Subject: Class 2 Permit Modification Request, Hazardous Waste Facility Permit Number:
NM4890139088-TSDF

Class 2 Permit Modification Request

Update Panel 8 Volatile Organic Compound Room-Based Limits

**Waste Isolation Pilot Plant
Carlsbad, New Mexico**

Figure 2: Panel 8 As-Built (January 2018)

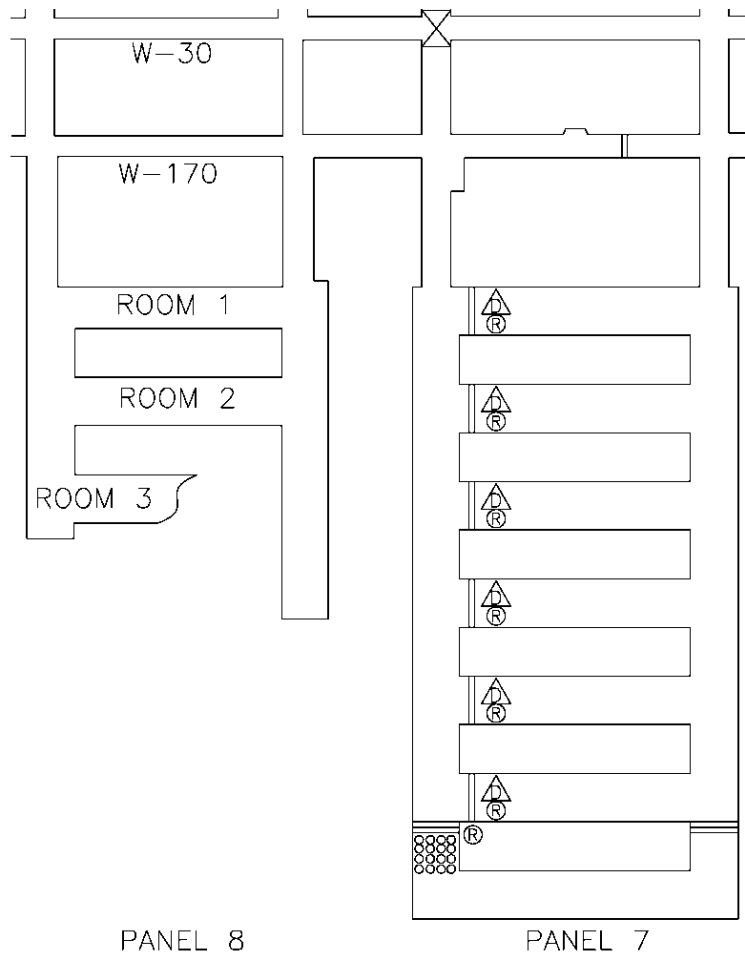
Prior to the February 2014 fire and radiological event, Panel 8 mining began on the lower horizon, below Clay G (refer to Figure 1). Panel 8, Rooms 1 and 2 were fully mined, and Room 3 was partially mined (refer to Figure 2).

Mining was suspended for approximately four years due to the February 2014 events. During the 4-year mining suspension, the back in Panel 8 developed significant low-angle shear fractures. To ensure long-term stability and safety of the panel after operations resumed, the decision was made to re-mine the existing back and to change the mining horizon for the remainder of Panel 8 to the upper horizon (*i.e.*, the back located at Clay G). With the back at Clay G and the floor nominally two feet below the Orange Marker Bed, 16-foot high drifts and rooms were needed.

Figure A3-2
Typical Disposal Panel Dimensions for Panel 8

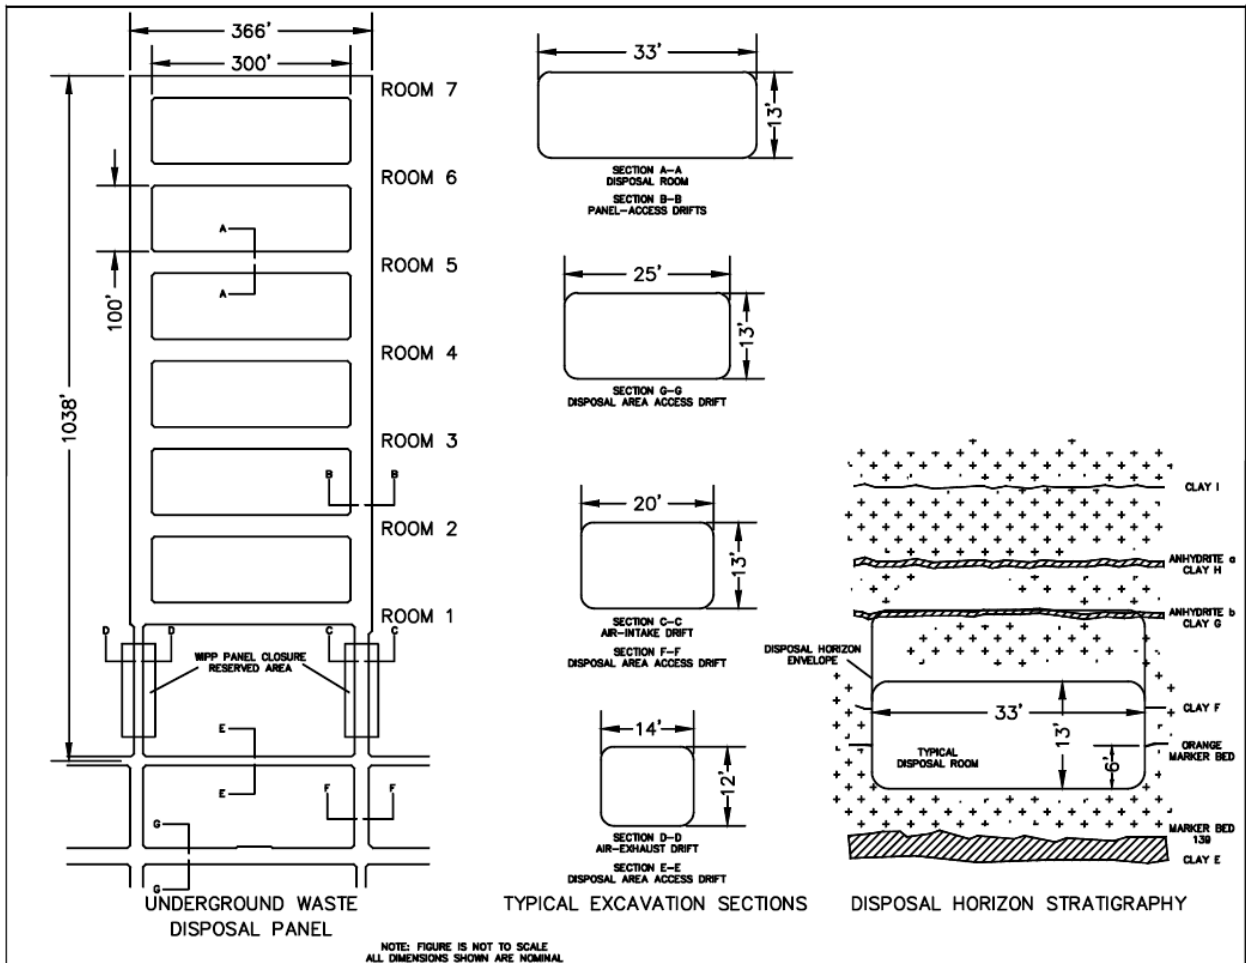
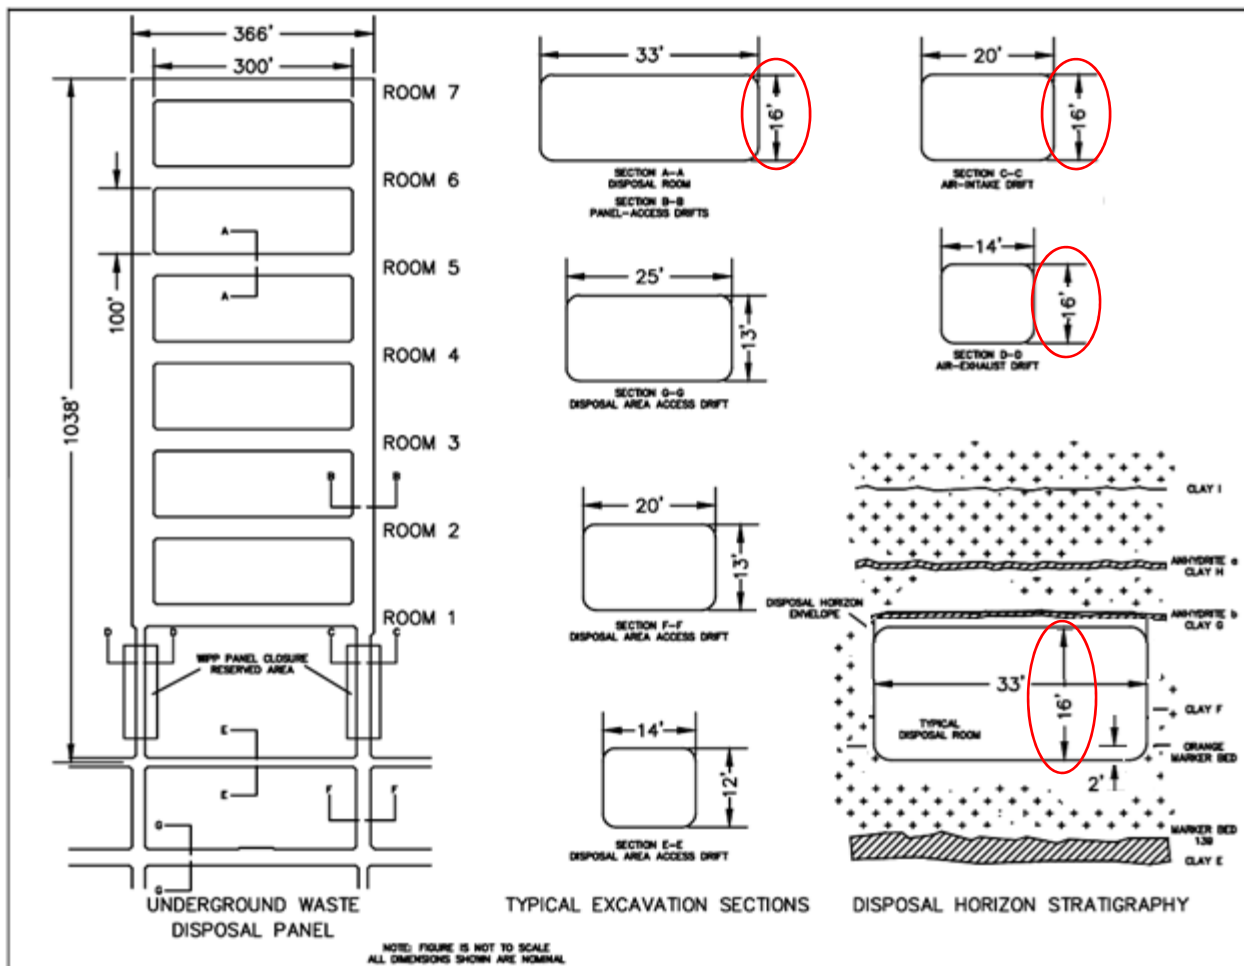
- Permit Attachment A3, *Typical Disposal Panel*.
 - Figure nomenclature is added to the existing figure along with a modification to the figure title. The modification reads as follows: “Figure A3-1, Typical Disposal Panel Dimensions for Panels 1-7”.

- A new figure, “Figure A3-2, Typical Disposal Panel Dimensions for Panel 8”, is added to illustrate the change in room height for Panel 8.
- Permit Attachment G, *List of Figures*.

Figure G-5b
Typical Disposal Panel Dimensions for Panel 8

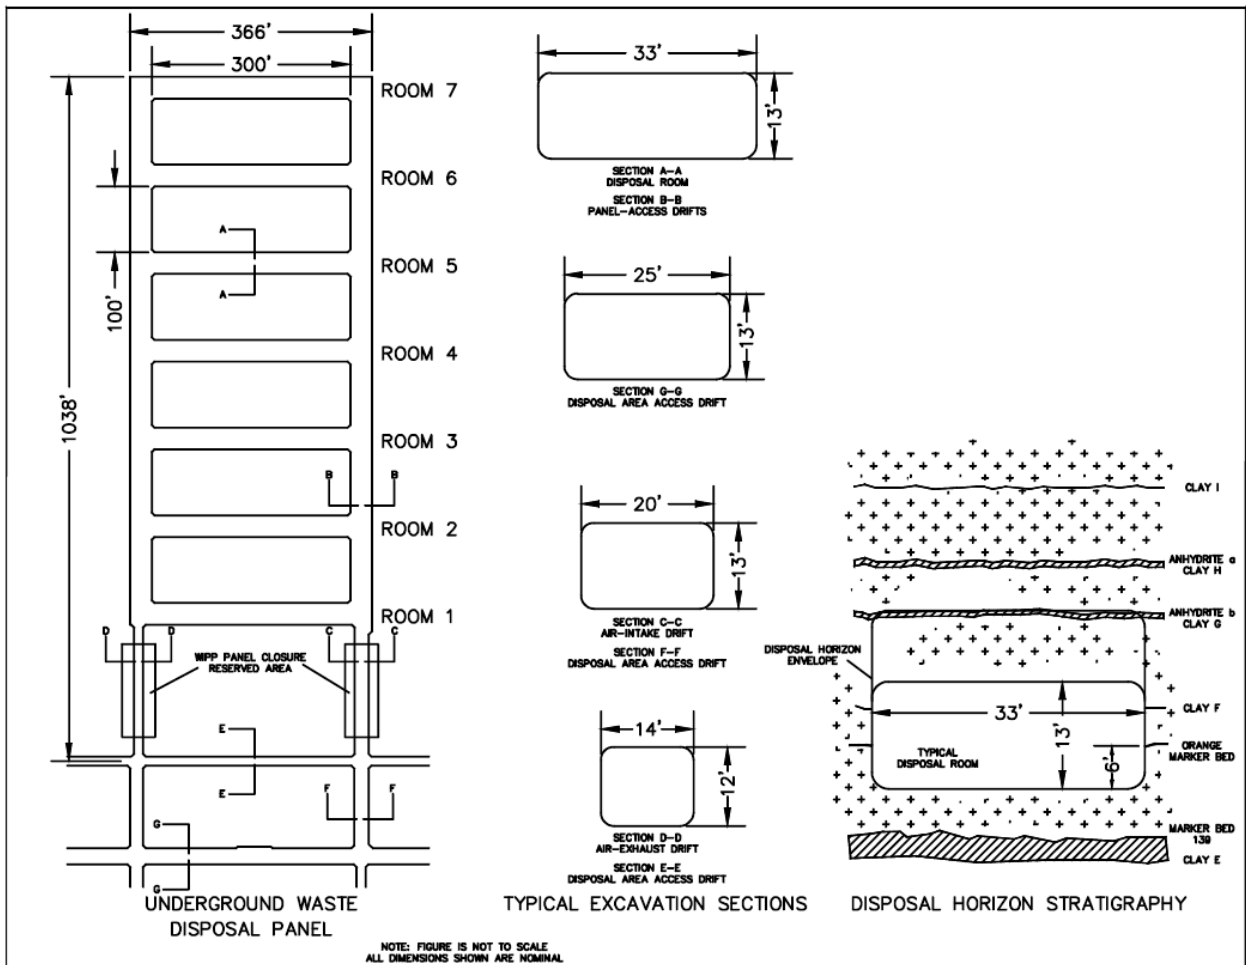
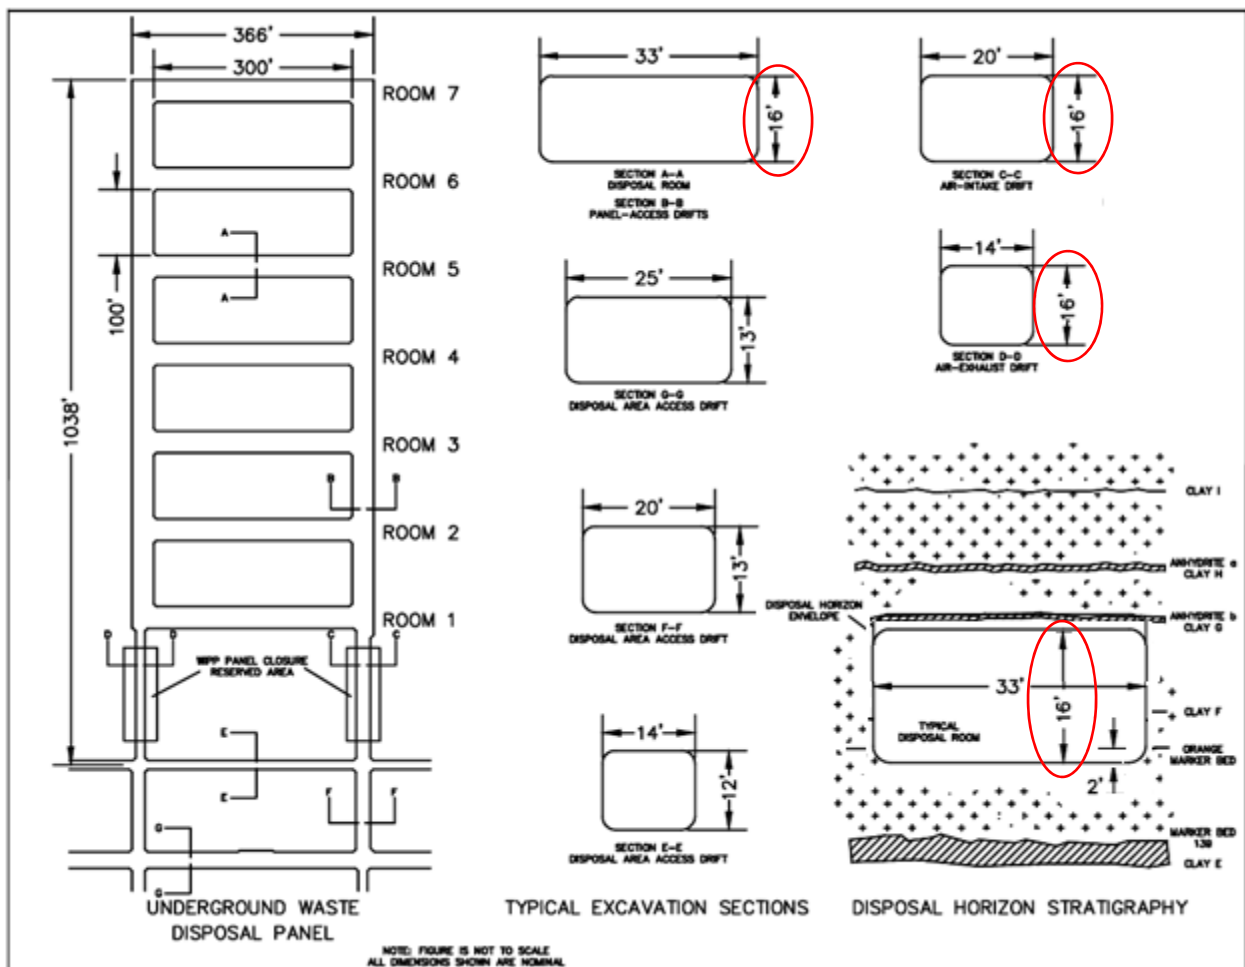
- The existing figure, Figure G-5, is being separated into two figures, Figure G-5a and Figure G-5b to differentiate between Panels 1-7, and Panel 8, respectively.

- Permit Attachment G, *Figures*.
 - The existing figure title of Figure G-5 is modified from “Figure G-5, Typical Disposal Panel,” to, “Figure G-5a, Typical Disposal Panel Dimensions for Panels 1-7”

- A new figure, “Figure G-5b, Typical Disposal Panel Dimensions for Panel 8”, is added to illustrate the change in room height for Panel 8.

Figure N-4b
Disposal Room Sample Head Arrangement for Panel 8

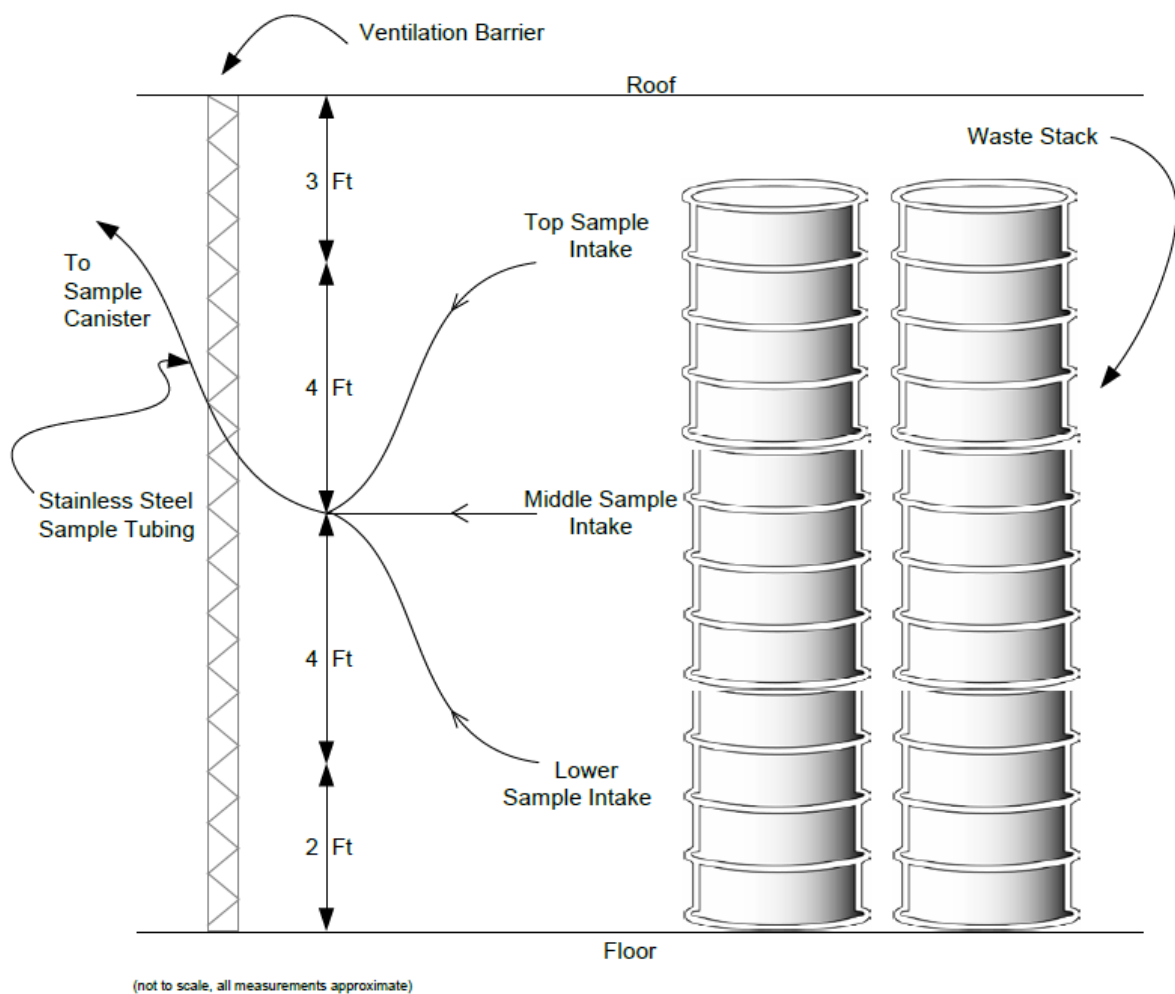
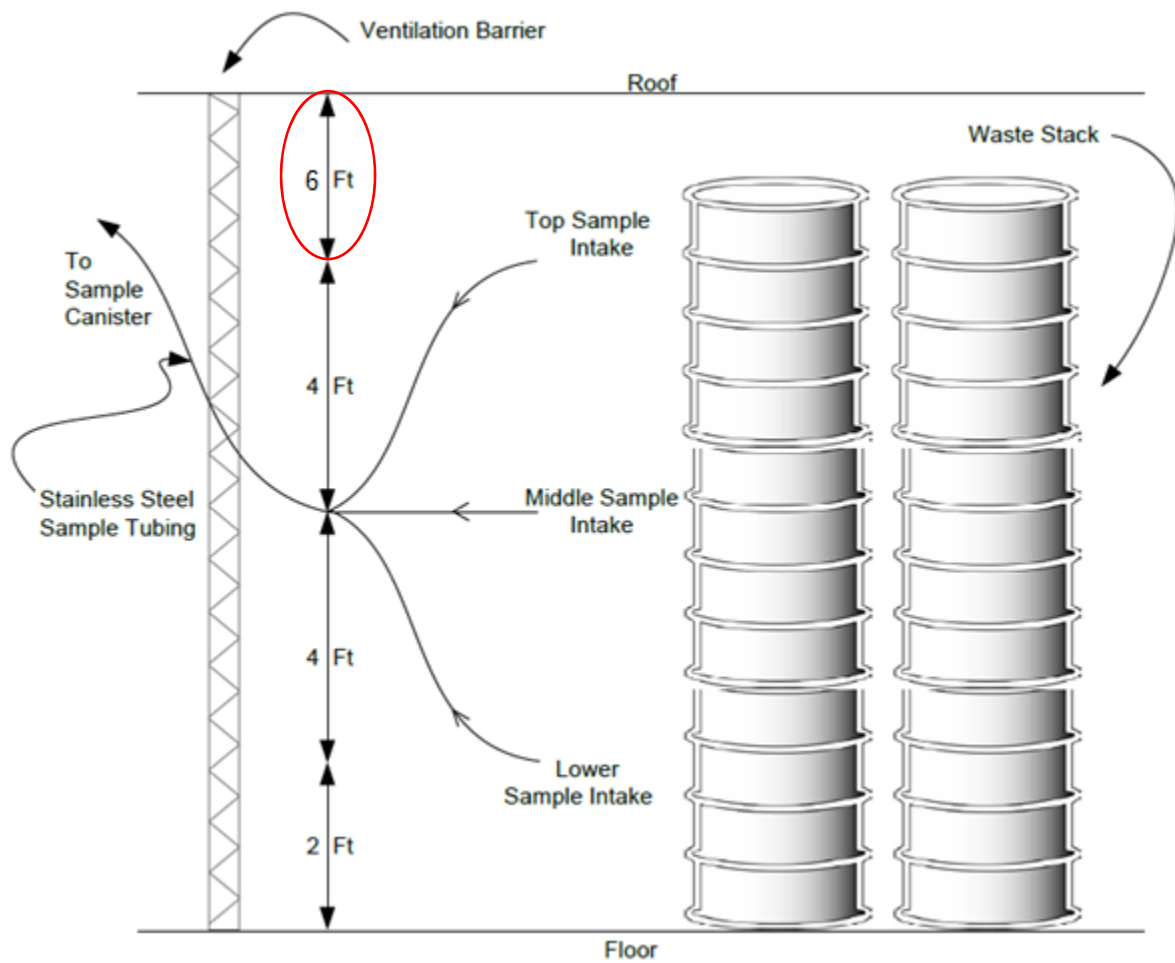
- Permit Attachment N, *List of Figures*.
 - The existing figure, Figure N-4, is being separated into two figures, Figure N-4a and Figure N-4b to differentiate between Panels 1-7, and Panel 8, respectively.

- Permit Attachment N, *Figures*.
 - The existing figure title of Figure N-4 is modified from “Figure N-4, Disposal Room Sample Head Arrangement,” to, “Figure N-4a, Disposal Room Sample Head Arrangement for Panels 1-7”.

- A new figure, “Figure N-4b, Disposal Room Sample Head Arrangement for Panel 8”, is added to illustrate the change in room height for Panel 8.

Figure C-9: Panel 8 Room Dimensions

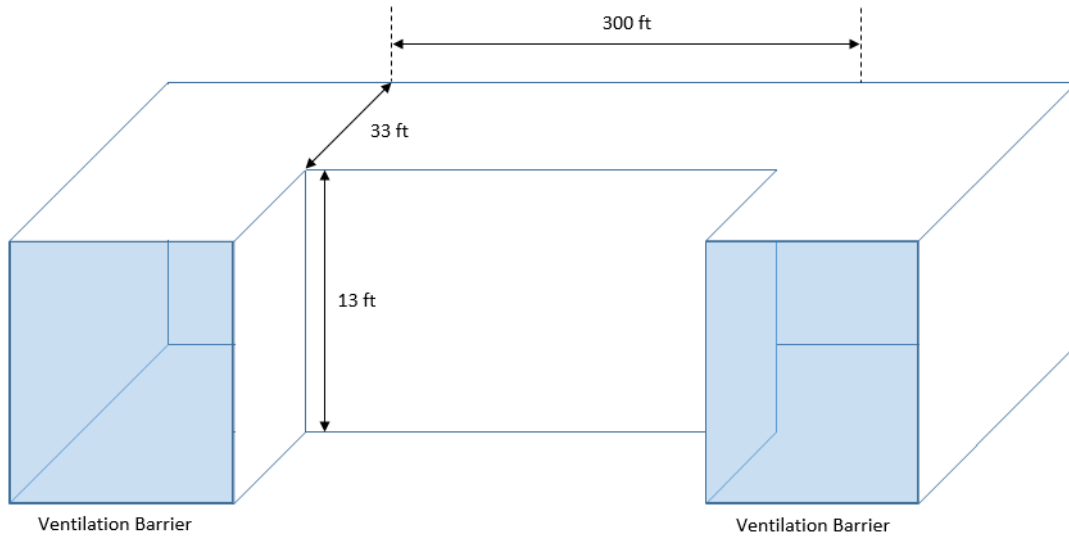
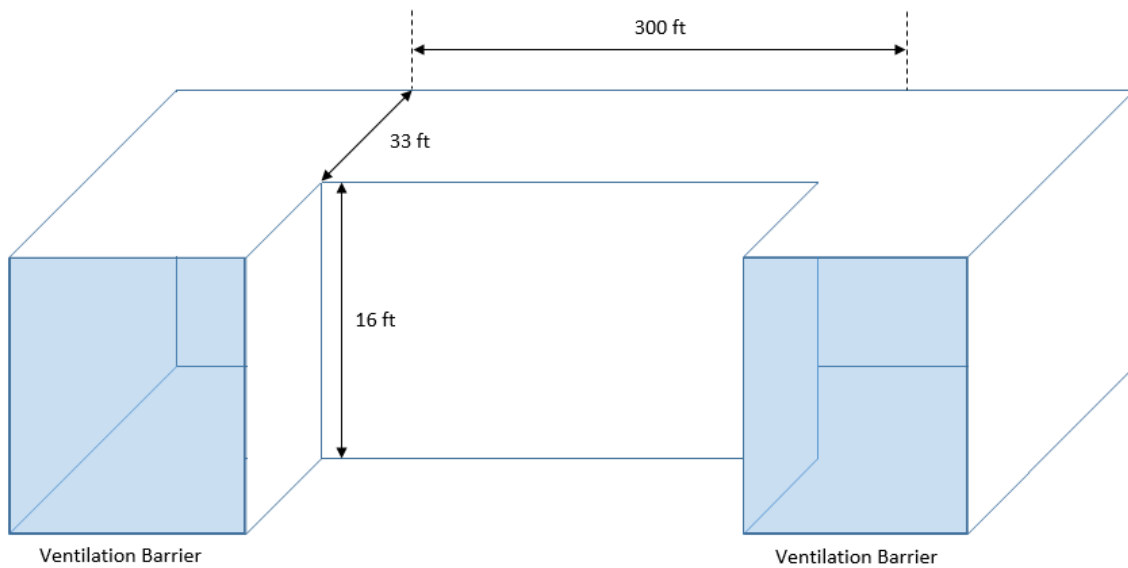
The same hypothetical adjacent closed room scenario and calculation methodology is used to determine the VOC room-based limits for Panel 8. The parameters previously discussed remain the same with the exception of the disposal room height. For Panel 8, the room height will be 16 ft instead of 13 ft, as in the original design. To provide an equivalent level of protection to the worker in the active room, the VOC room-based limits for Panel 8 are changed accordingly.

Because the Panel 8 room height dimension is larger than the original panel design, the room headspace volume in the adjacent closed room increases from 1.5 feet to 4.5 feet. This increases the room headspace volume (**RHV**), which will change the health-based VOC room-based limits for Panel 8. Figure C-10 illustrates the modified scenario.
